AS PROPOSED

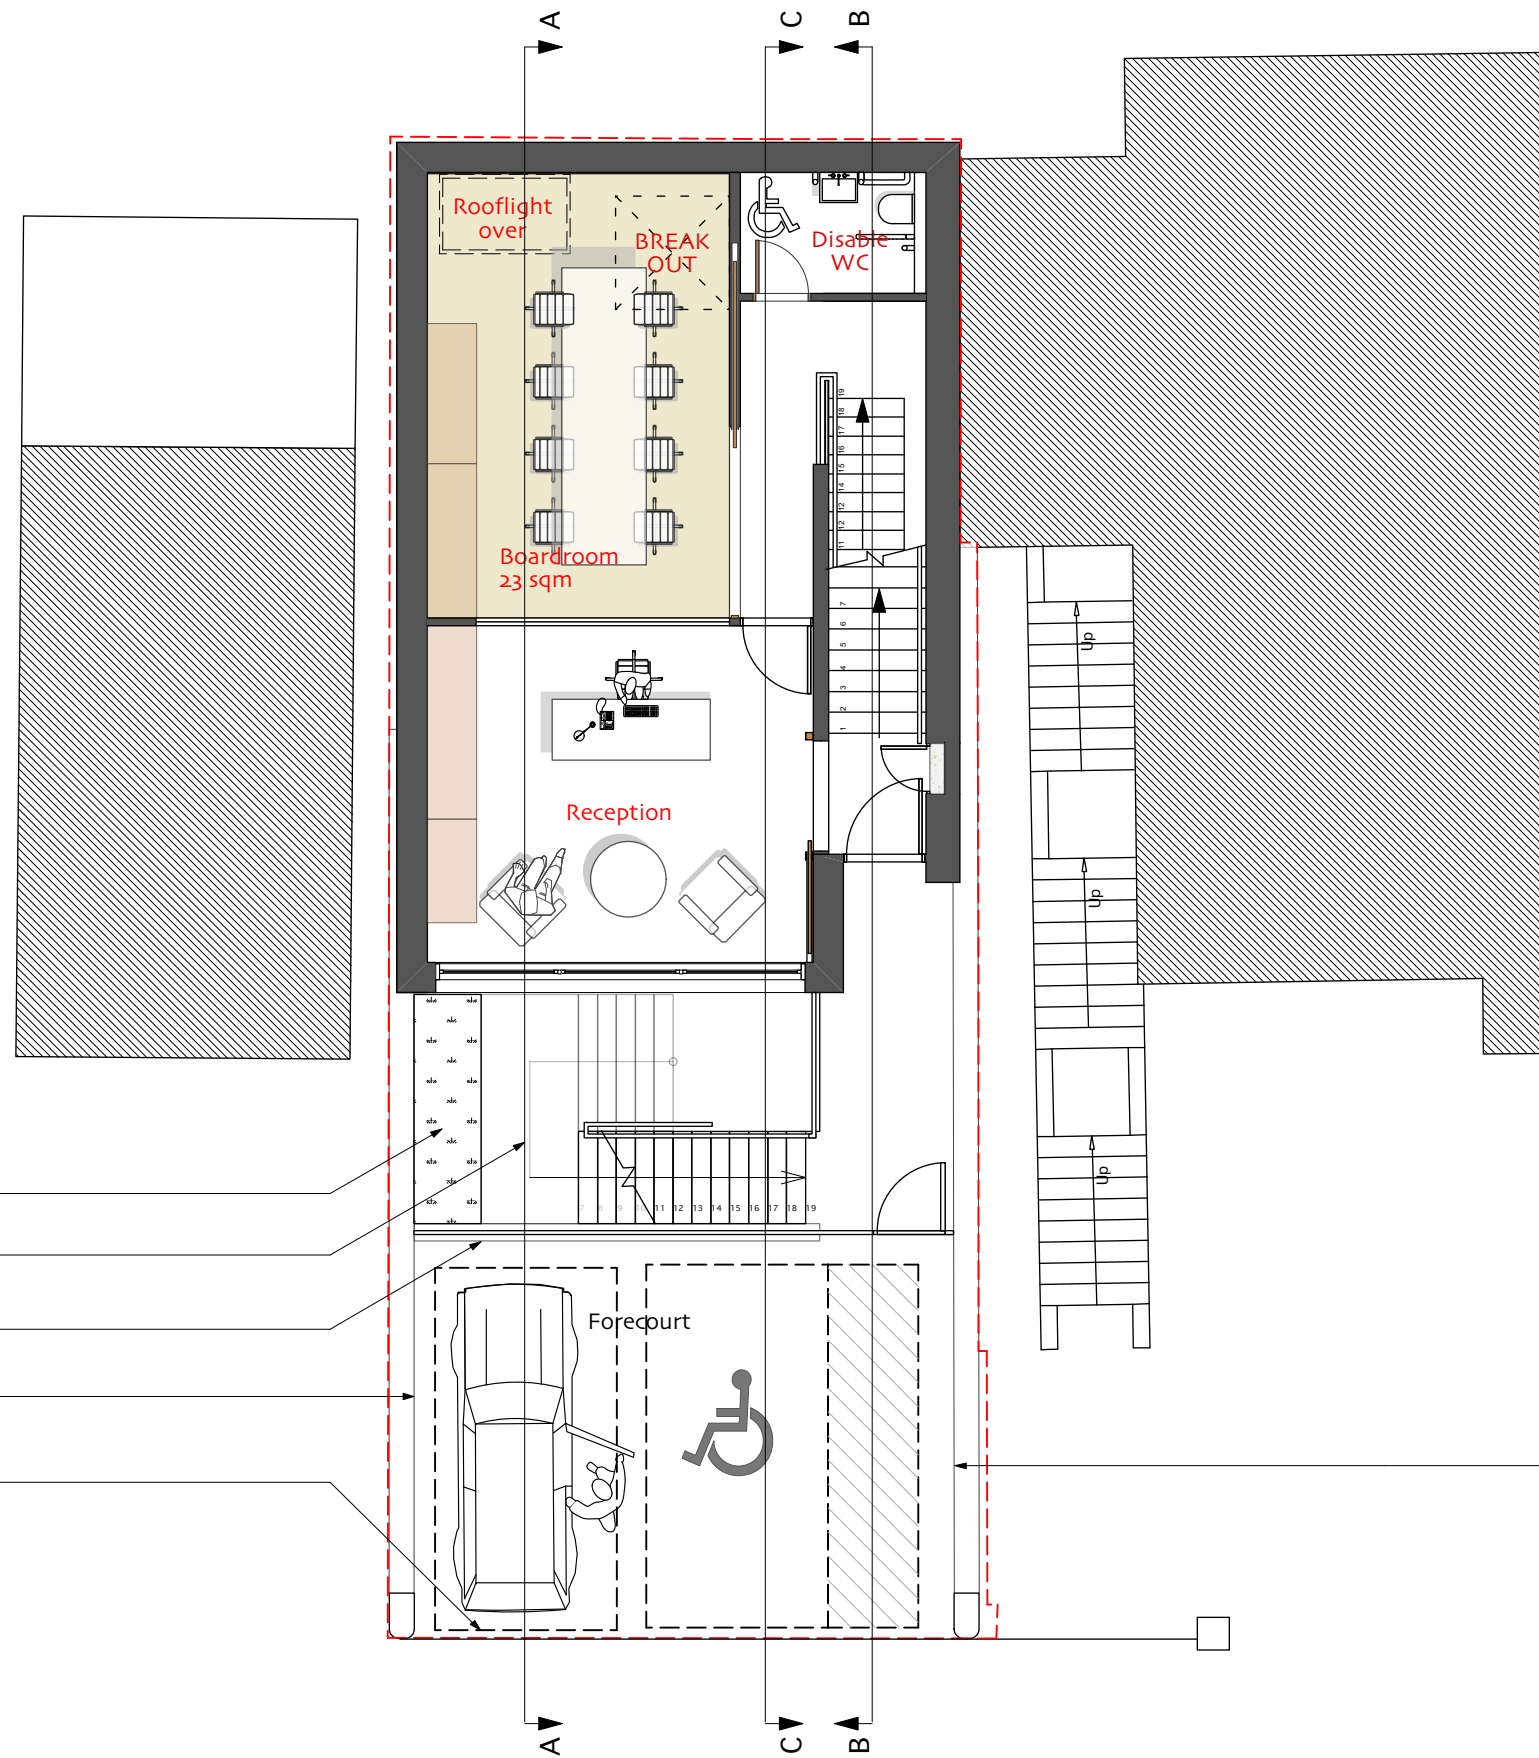
water feature added
 stair widened, landing added
 Basement size & shape as built

Drainage manhole at back-of-pavement

AS PROPOSED

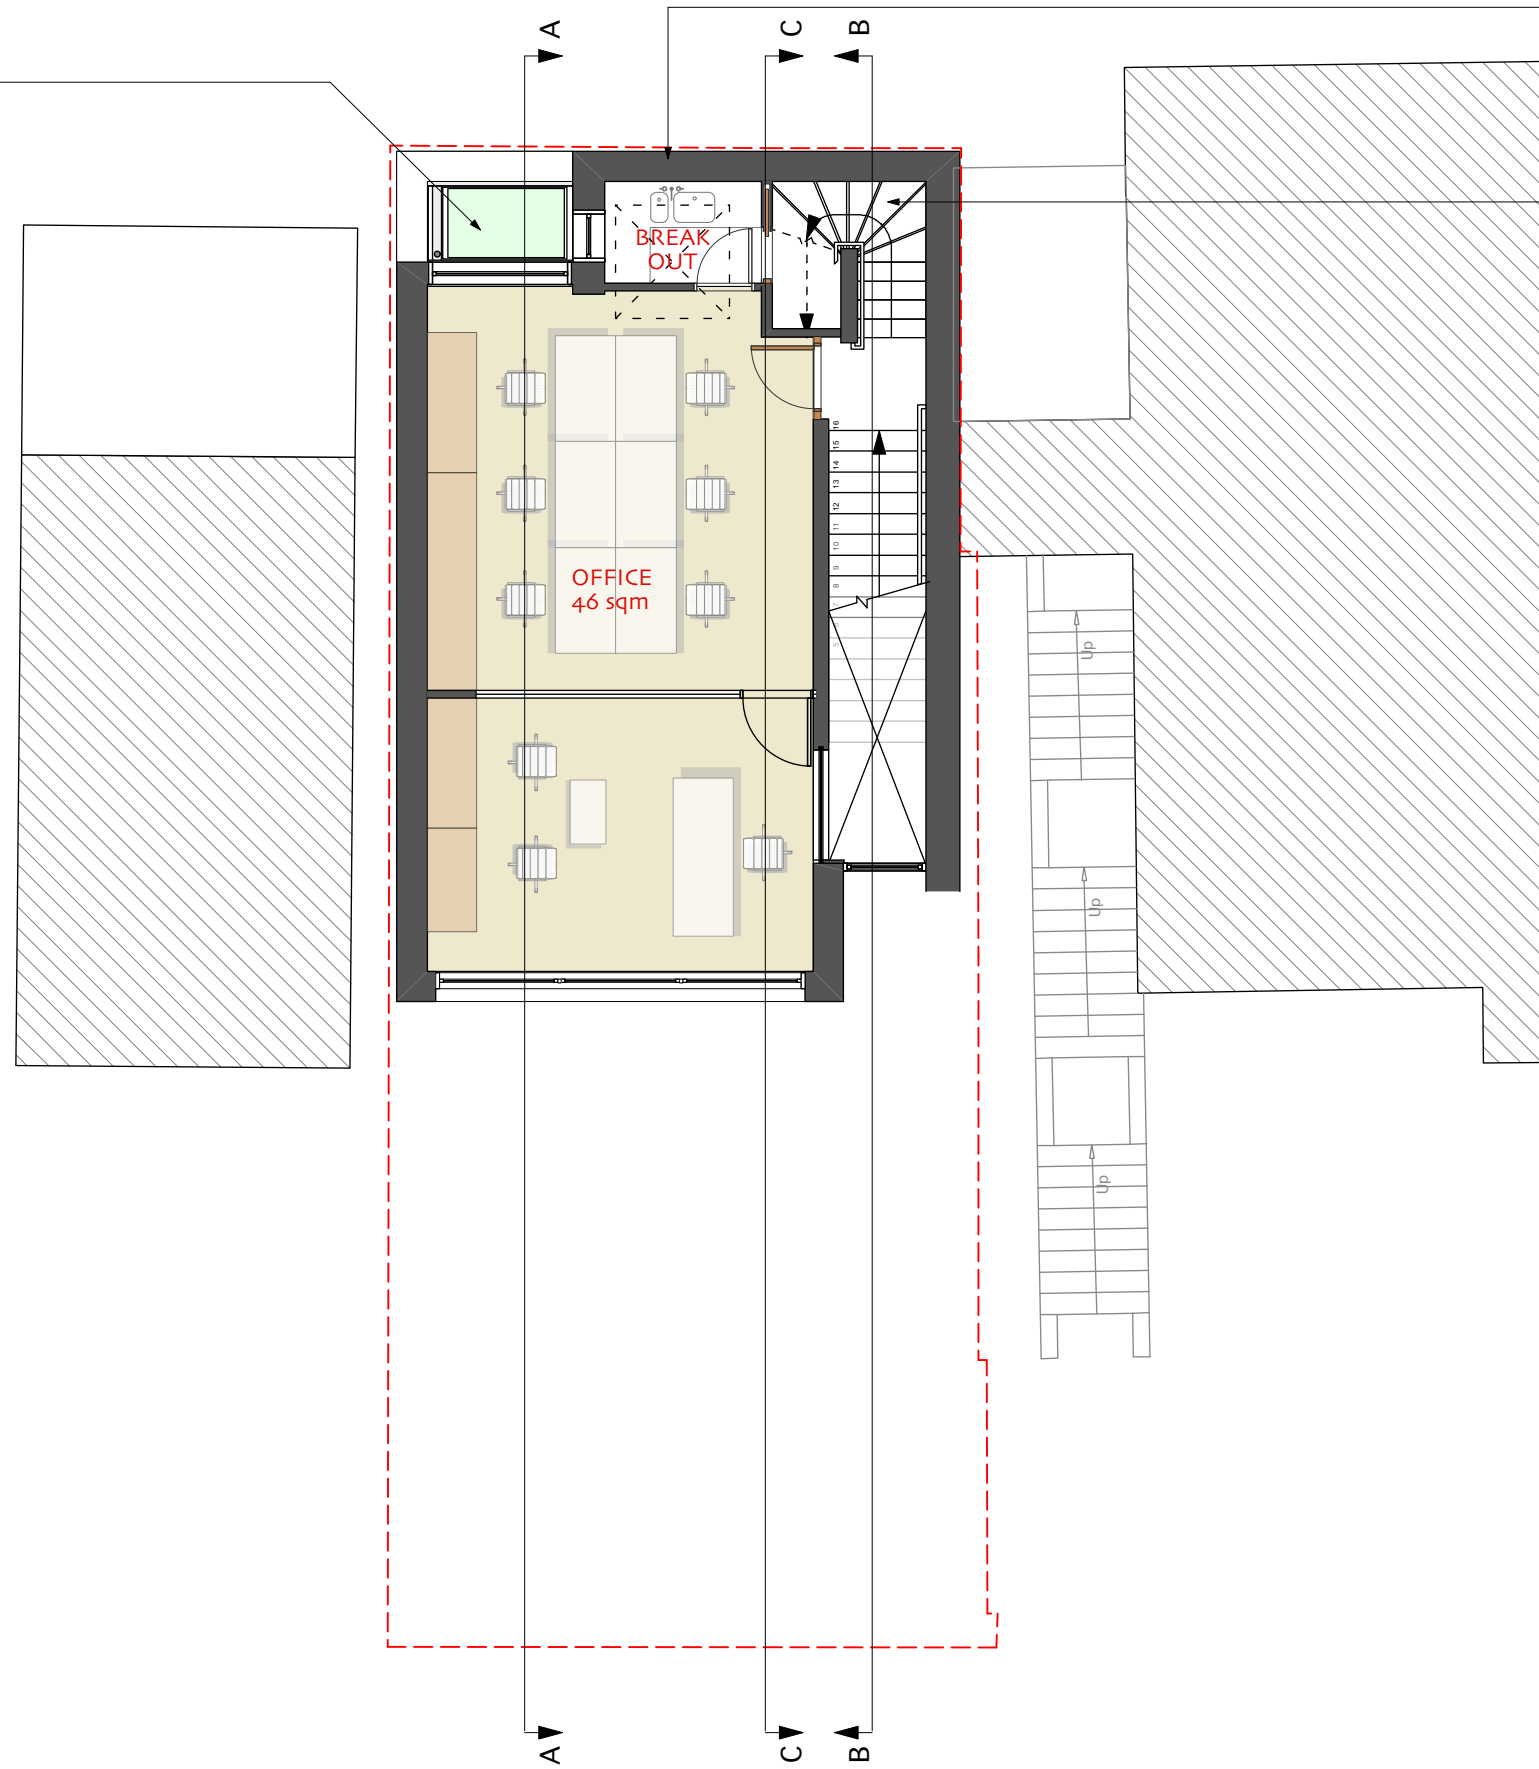
- planter added
- stair widened, landing added
- gate moved back behind forecourt
- Street number & company name lettered onto inner face of wall
- sliding gates replaced by railings

Street number & company name lettered onto inner face of wall

rooflight recessed so as not to discharge rainwater over neighbouring property

WC changed to tea point

AS PROPOSED

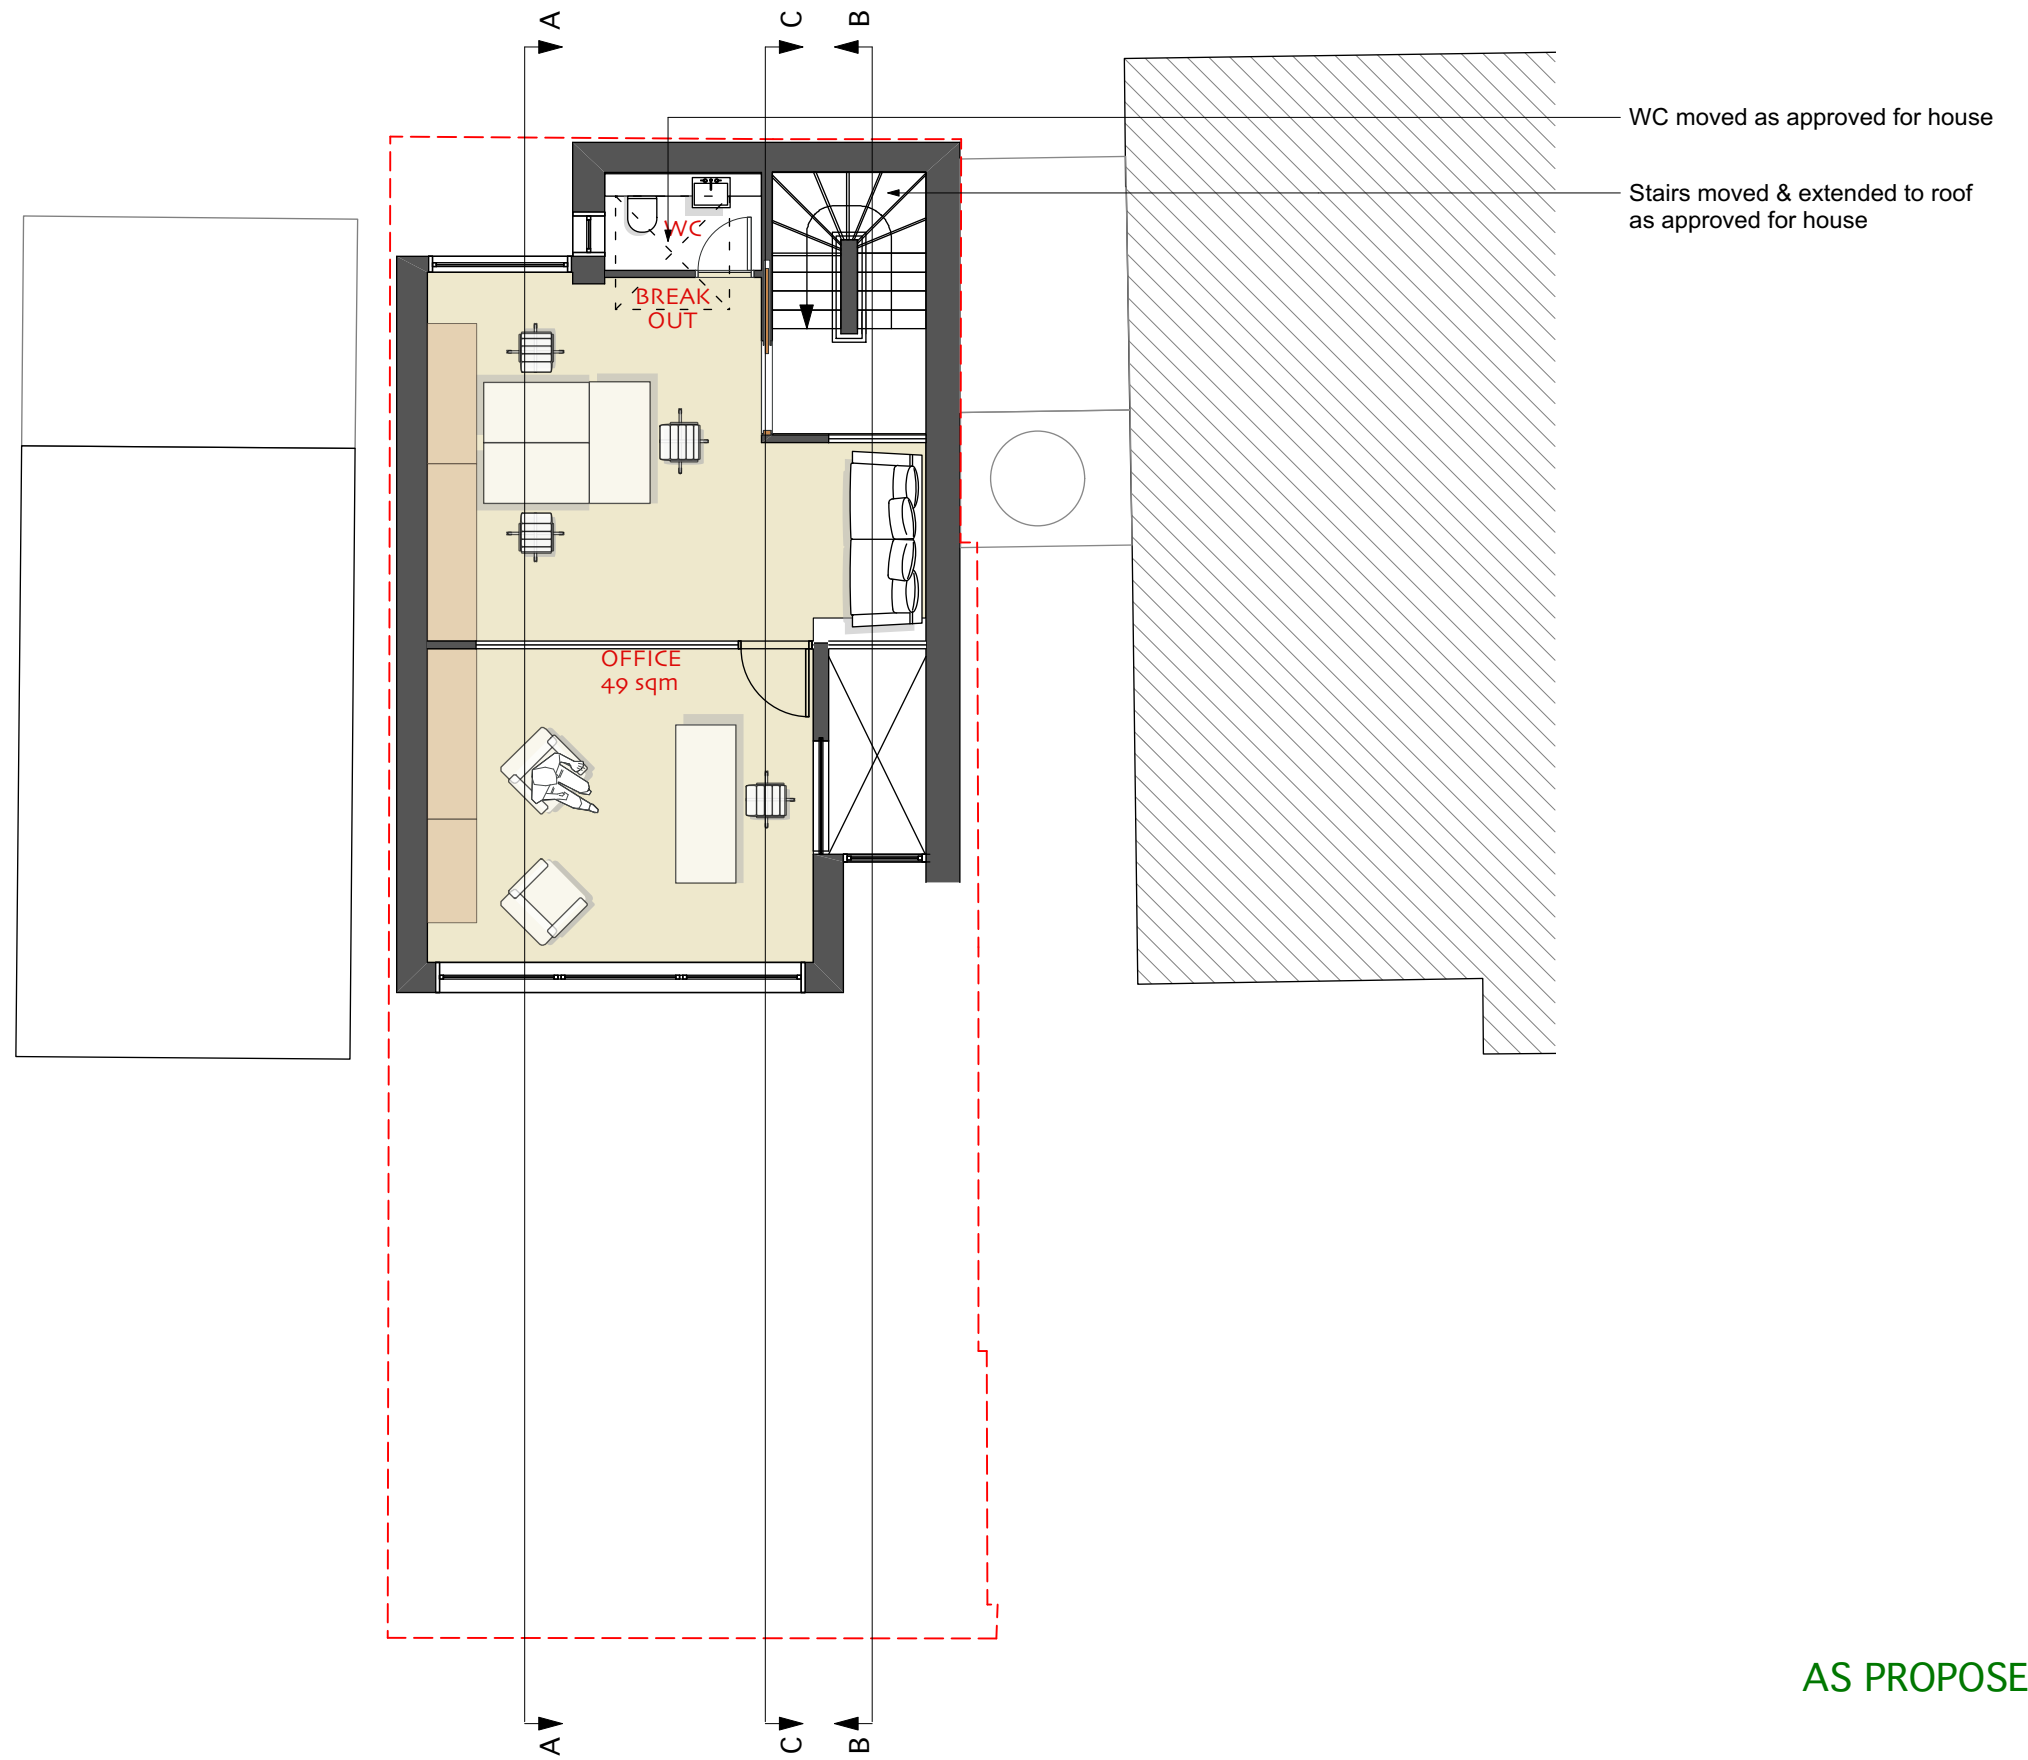
Stairs moved as approved for house
